TO: NH Site Evaluation Committee
FROM: Carl Martland, Chair, North Country Scenic Byways Council
RE: Impact of Northern Pass on North Country Scenic Byways
DATE: January 20, 2016

1. Background on the Scenic Byways of Northern New Hampshire

Four NH Scenic Byways Would be Affected by the Northern Pass Project

Figure 4 Comparing the Visual Impacts of the Major Alternatives (Northern Section)

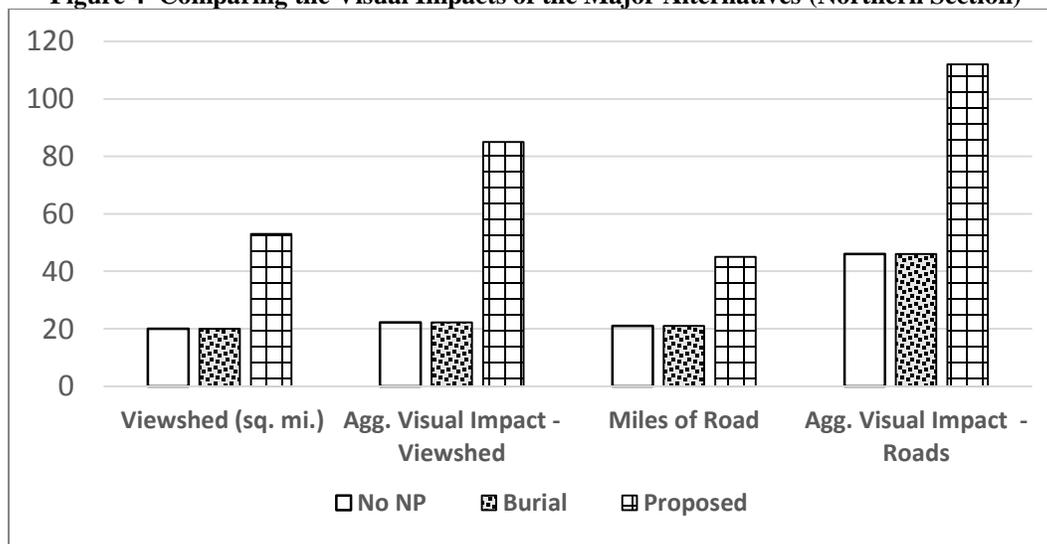
Figure 4 shows that the proposed project would more than double the areas exposed to transmission towers and transmission lines; the viewshed would increase 165% from 20 to 53 square miles and the miles of roads exposed to the towers would increase from 21 to 45. The aggregate measures of visual impact would increase by an even greater amount. If the lines were buried, the visual impact would be negligible. Using average measures for the viewshed, as was done in the draft EIS, underestimates the visual impacts, which is why NC SBC recommends using aggregate measures.

1. The overall visual impact cannot be represented by using the average impact over the viewshed, ignoring the fact that the size of the viewshed would more than double. We suggest using an aggregate measure that multiplies the average impact by the size of the viewshed as illustrated above in Table 5 and Figure 4.
